To: Plan Holders for Improvements to the
Monett Regional Airport
Pierce City, Missouri
Project No. 20-098B-1

Schedule I – Earthwork and Grading for Relocation of Runway 18/36

**ADDENDUM NO. 4
TO
CONTRACT DOCUMENTS, SPECIFICATIONS AND PLANS
FOR IMPROVEMENTS TO THE
MONETT REGIONAL AIRPORT
PIERCE CITY, MISSOURI
PROJECT NO. 20-098B-1**

G002

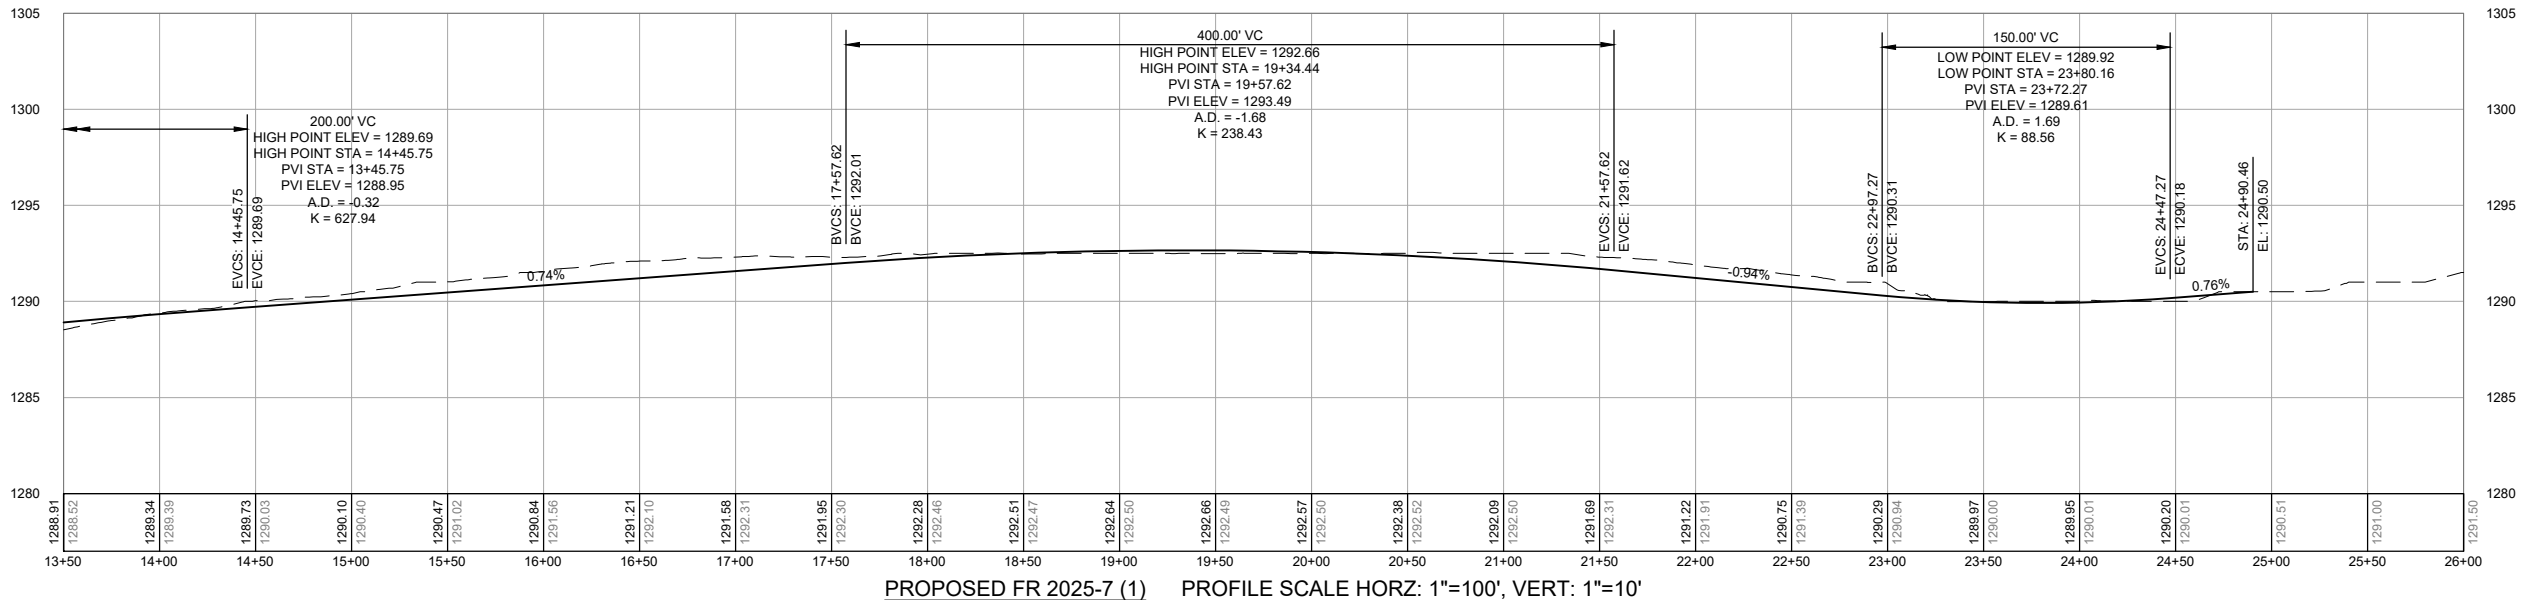
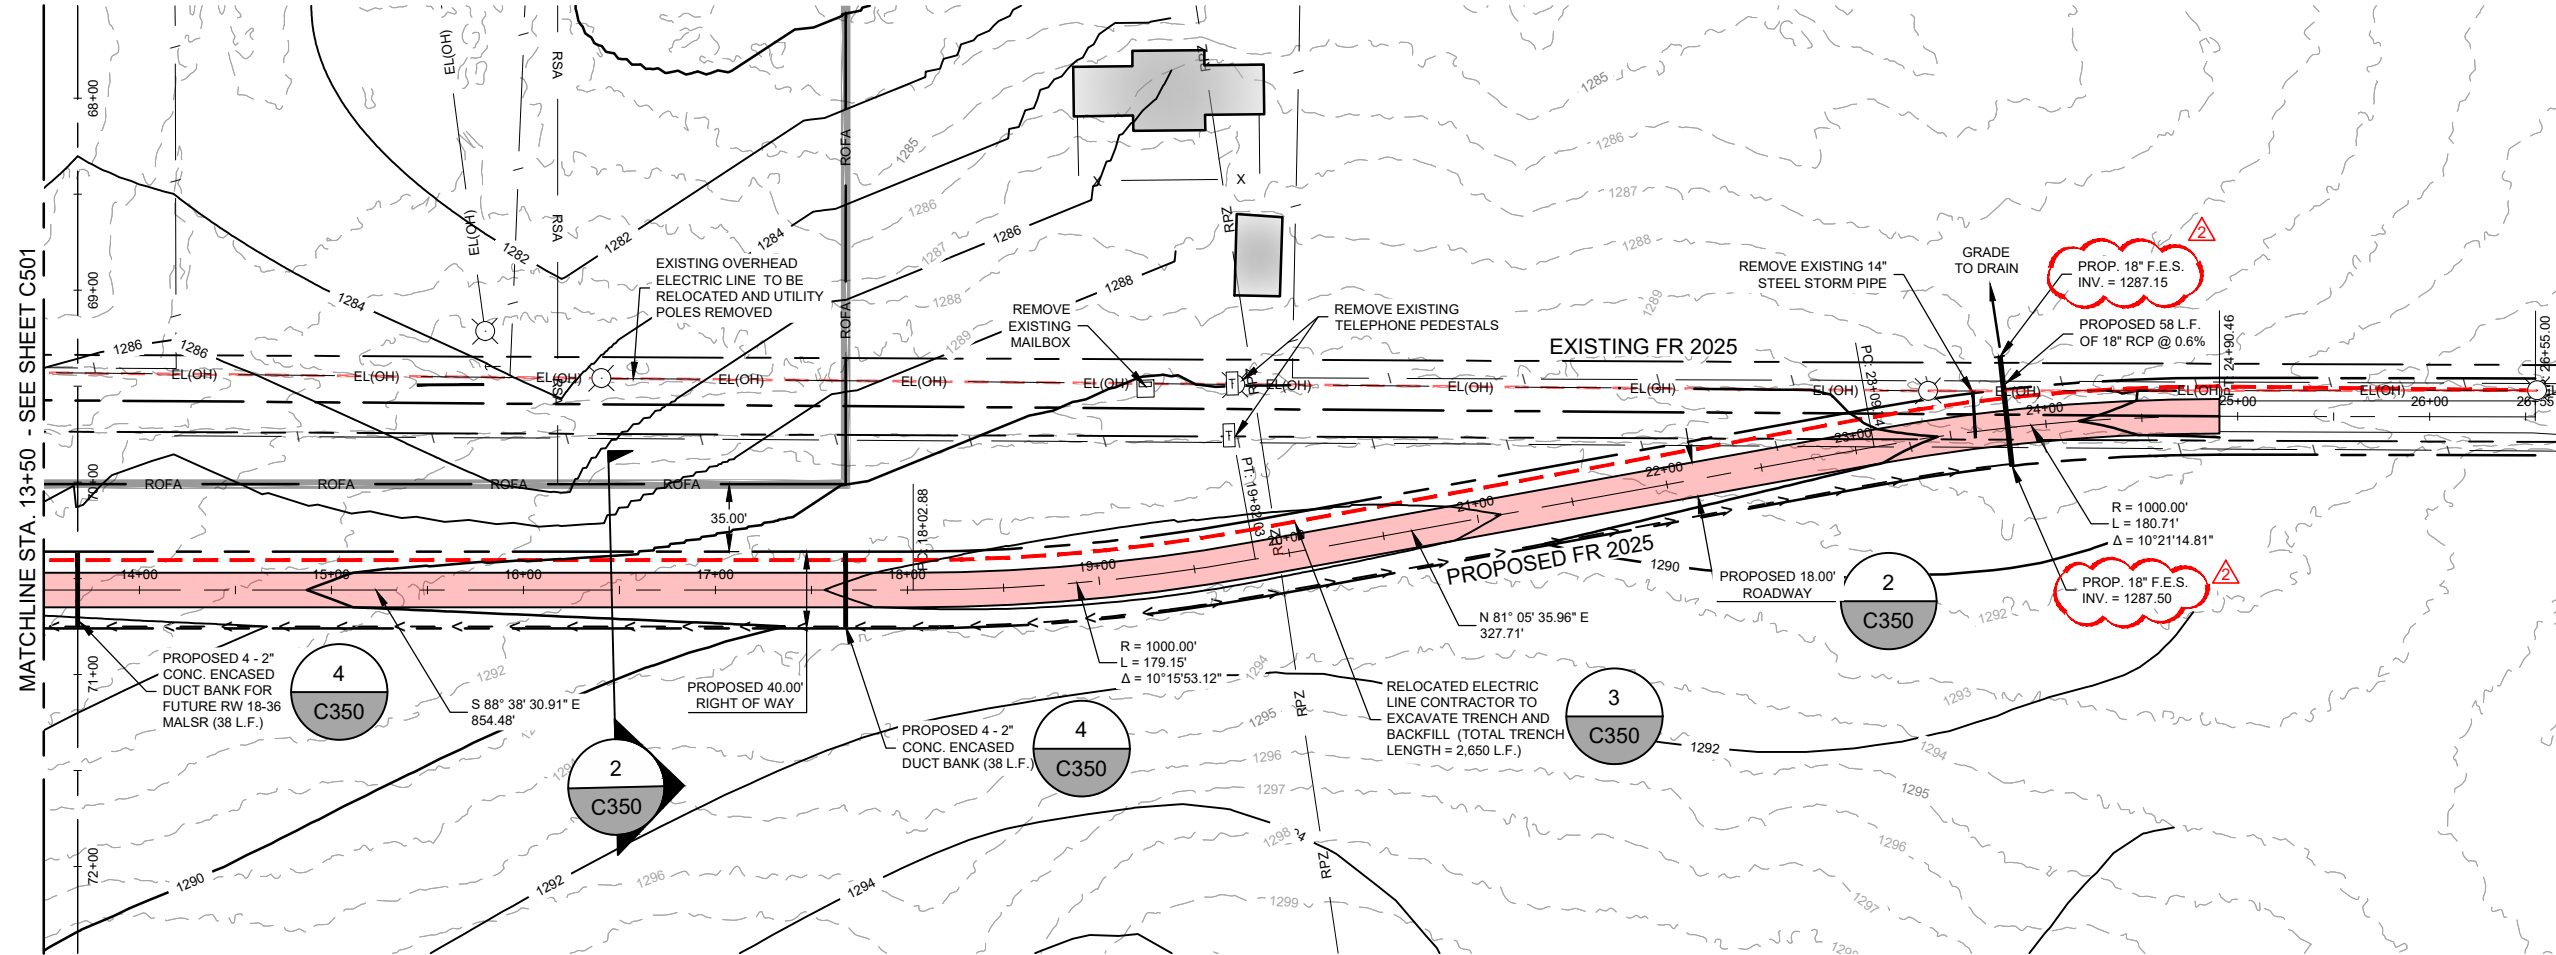
Sheet: G002

Title: Index of Drawings and Summary of Approximate Quantities

Revision: The quantities table was updated to reflect a change in bid items for D-701g, D-701k and D751a

26. Item D-751a indicates a quantity of 2-EA and D-751b a quantity of 1-EA, for a total of 3 inlets. Our takeoff based on profile notes indicates quantities of 2-EA & 0-EA, respectively.

- a. See revised sheet G002, attached, for updated quantities.
27. We routinely supply OMNI-FLEX® rubber tongue and groove joint gaskets which meet the requirements of MoDOT Sec. 1057.9 (see enclosed data sheet for that material) for RCP and RCBC installations. This may not exactly comply with that noted within the specification, specifically Sec. 701-2.4. However, per Sec. 701-3.4.a., that may be only where "leak resistant" joints are required, i.e. if a rubber gasket is desired by Contractor where "soil tight" joints are indicated or assumed desired. Are "leak resistant" joints required for RCP? Would OMNI-FLEX® rubber joint gaskets be acceptable to supply for RCP and RCBC?

C501

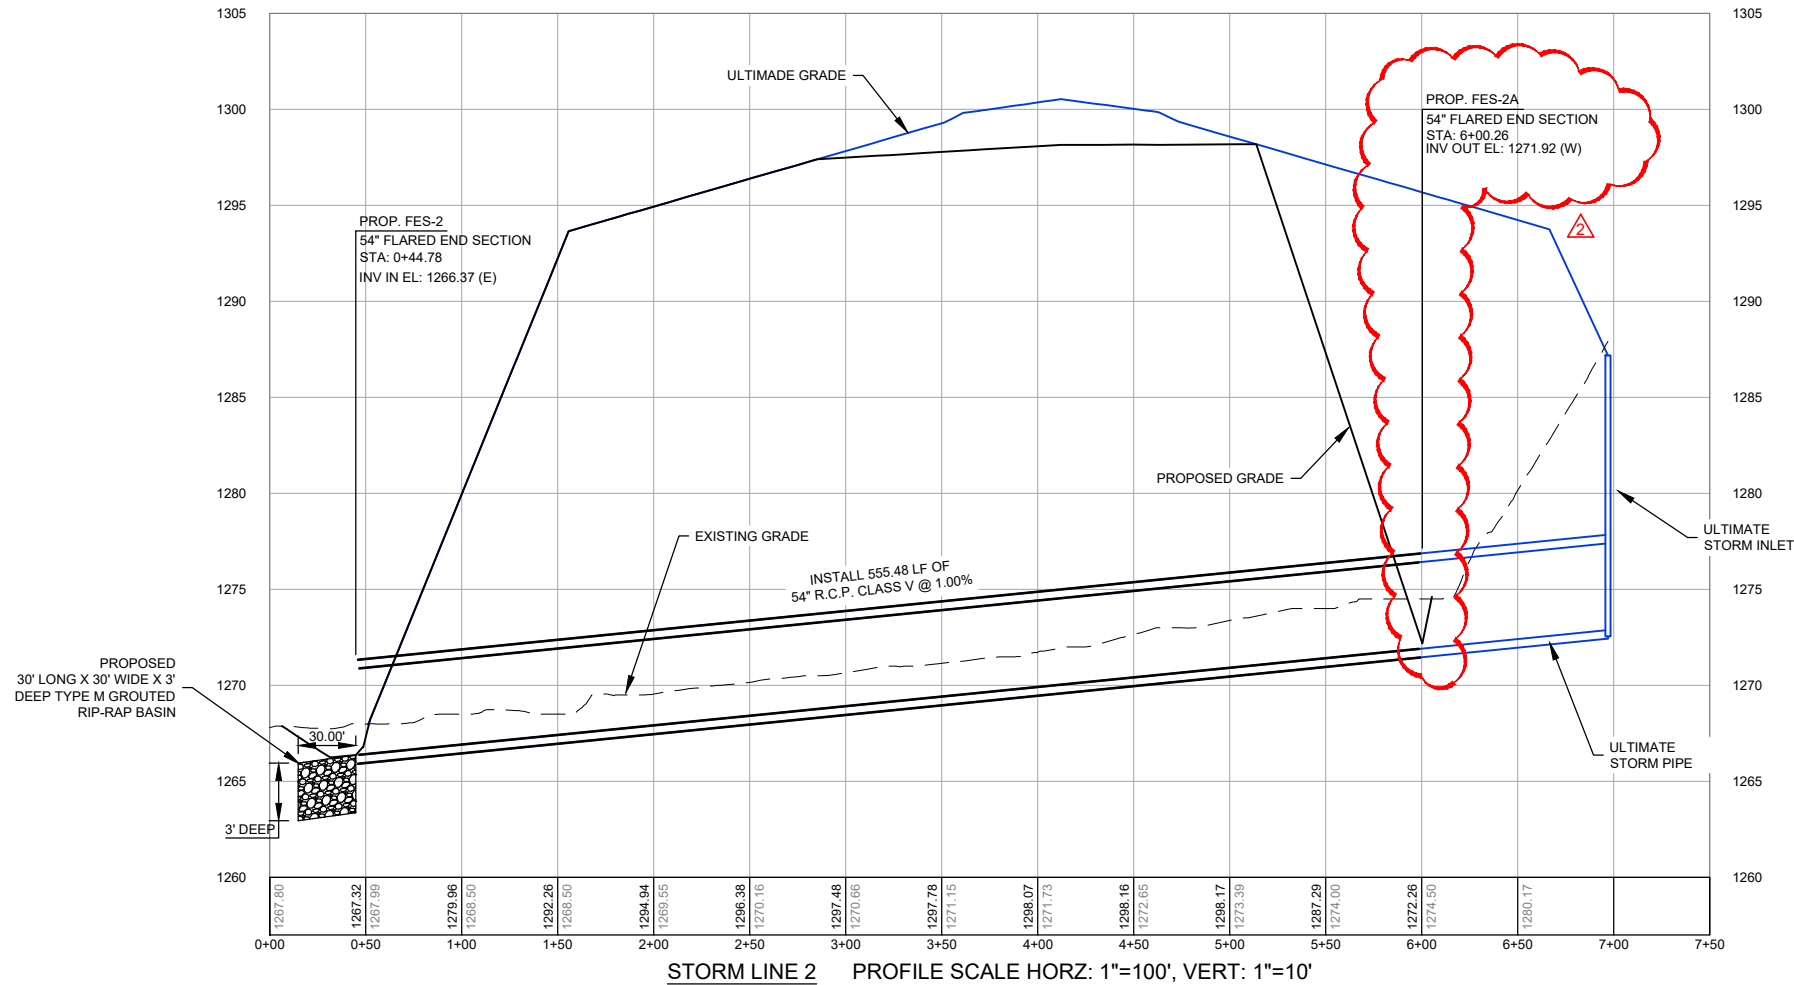
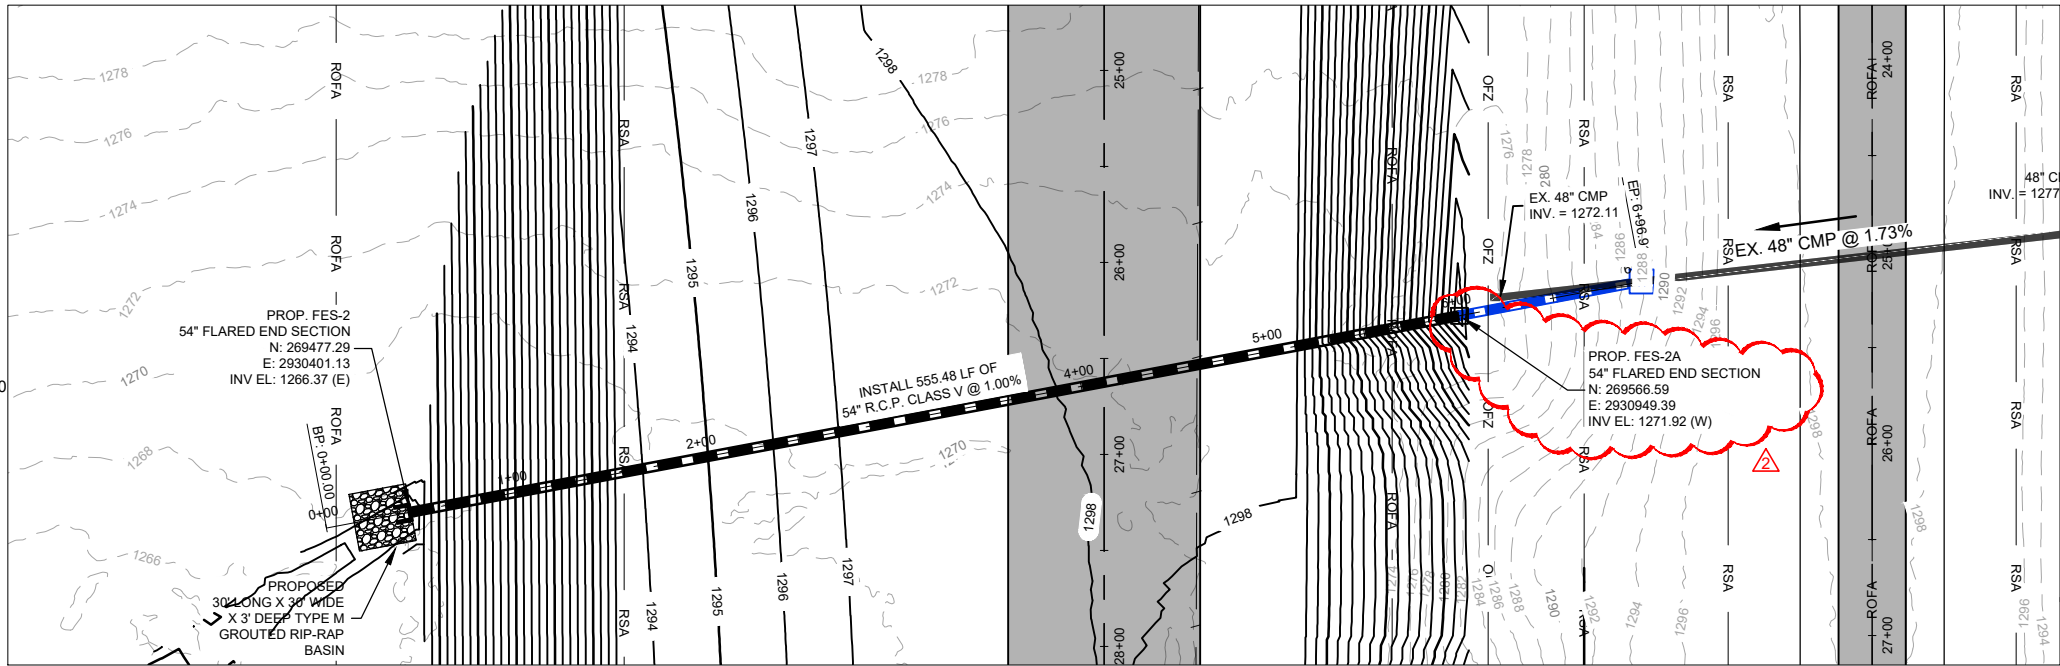
Sheet: C501

Title: Proposed FR 2025 Plan and Profile ST 13+50 to ST 26+00

Revision: Revised sheet to show 18" Flared End Sections (FES).

- b. Therefore, the asphalt pavement shall be placed Spring 2021, after hauling operations across FR 2025 are complete.
16. Does the road culvert receive FES's at inlet and/or outlet? None are shown.

- a. Yes, two additional 18” Flared End Sections (FES) will be required. See attached revised sheet C501.

C601

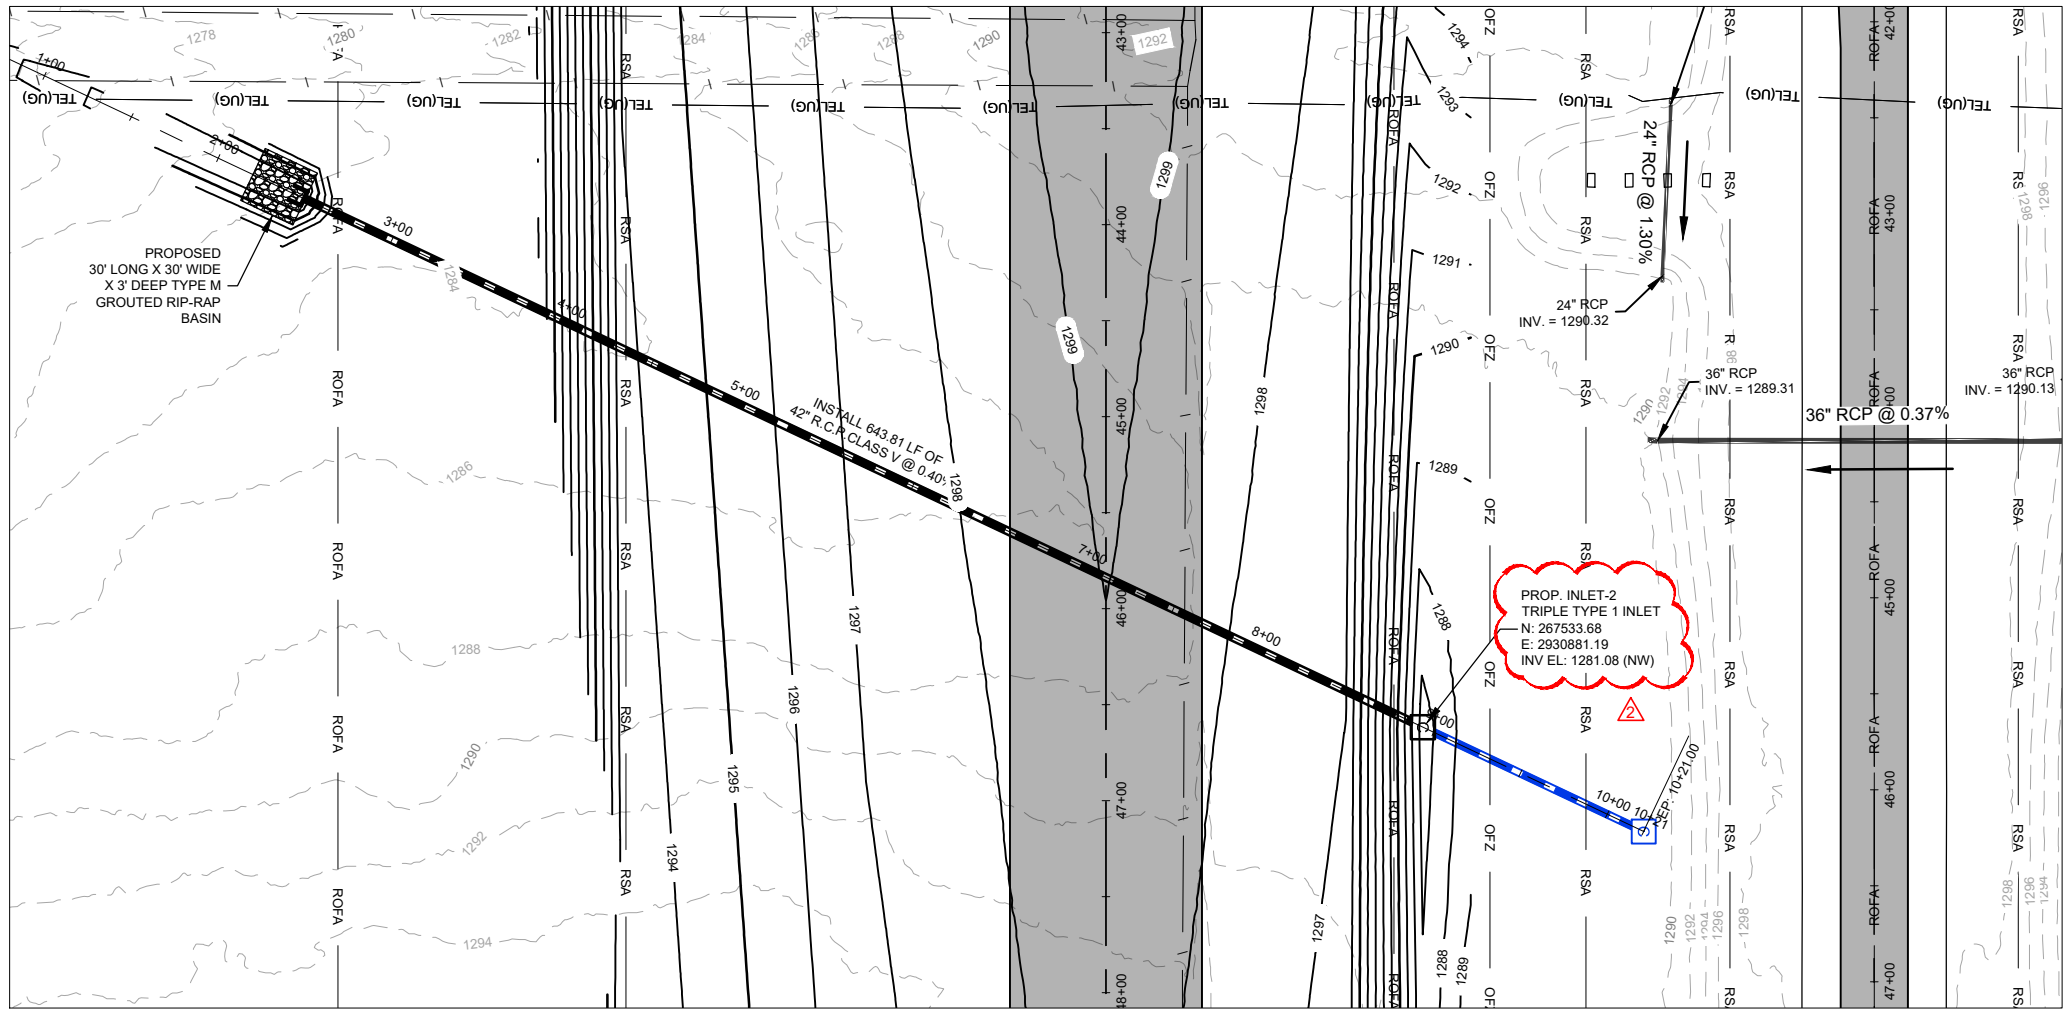
Sheet: C601, C602 and C604

Title: Proposed Storm Line 2 Plan and Profile, Proposed Storm Line 3 Plan and Profile, and Proposed Storm Line 5 Twin Box Culverts Plan and Profile

Revision: Updated profile to show where Install Aircraft Rated Triple Inlet is required and how the Reinforced Box Culvert (RCB) shall be designed by a licensed structural engineer hire by the contractor with their method of construction of the RCB.

18. Should the upstream end of pipes to be extended in the future receive FES? None are shown
 - a. Yes, see revised sheet C601, attached.
19. Does detention outlet pipe receive FES? None are shown.
